# DEVIATION REQUEST AND DECISION FORM

Project Name : Hillside at Lorson Ranch  
 Schedule No.(s) : 5500000370, 5500000371, 5500000405, 5500000281, 5500000282, & 5500000283  
 Legal Description : See Attached

**DEVIATION 2  
 EXHIBIT**

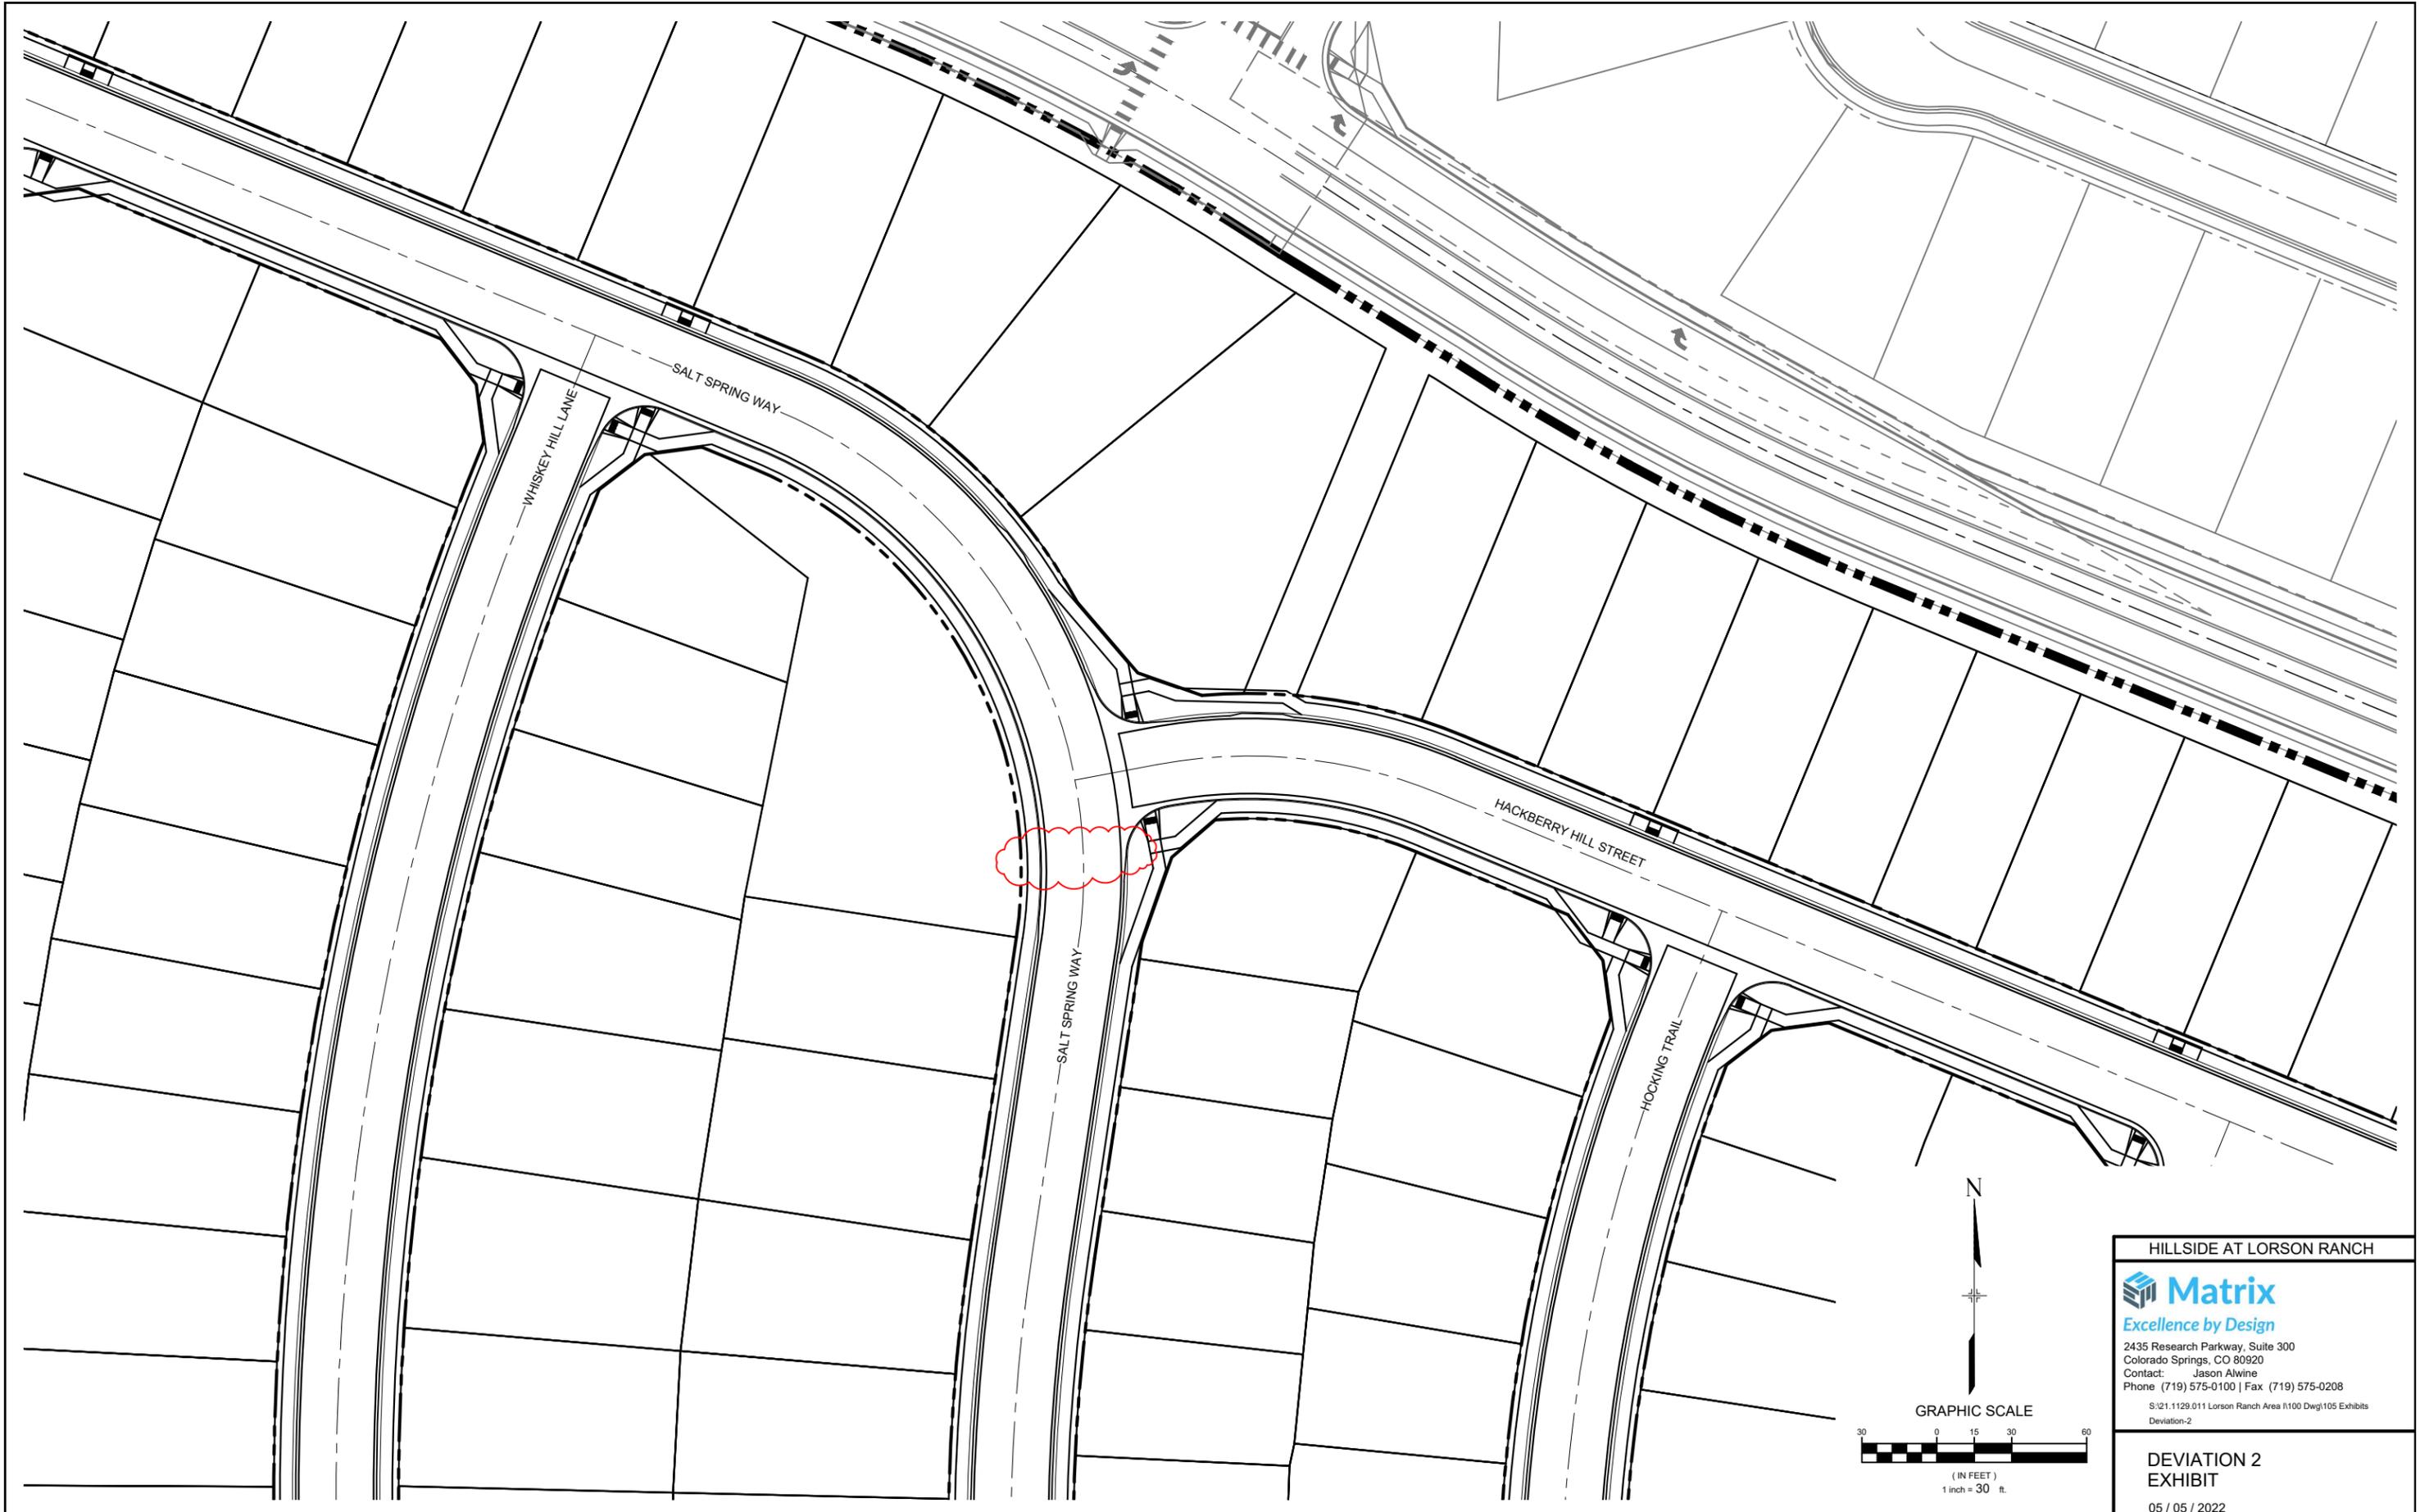
Allow only two pedestrian ramps to be constructed at the T-intersection of Hackberry Hill Street and Salt Spring Way.

The proposed alternative is to construct two pedestrian ramps crossing Hackberry Hill Street and no ramps crossing Salt Spring Way at this T-intersection. The ECM standard is for T-intersections to have a minimum of three curb ramps.

The intersection is in close proximity of other intersections with all the required ramps constructed. Installation of an additional ramp at this intersection is not feasible as the grading cannot meet ADA requirements along the ADA curb returns. The additional ramp may also be a safety concern as the removed crossing is in the middle of a large curve. The crossing at Salt Spring Way and Whiskey Hill Lane is approximately 225' feet away and provides a much safer intersection for pedestrian movements.

Elimination of one of the three ramps at this intersection will not impede pedestrian movements and will result in safer pedestrian crossing due to grading concerns and the inability to meet ADA slope requirements (where required). The additional ramp may also be a safety concern as the removed crossing is in the middle of a large curve. A pedestrian will be able to cross at alternate locations within approximately 225' of the eliminated ramps.

This request has been determined to have met the criteria for approval. A deviation from Section 2.5.2.(C2) of the ECM is hereby granted based on the justification provided.
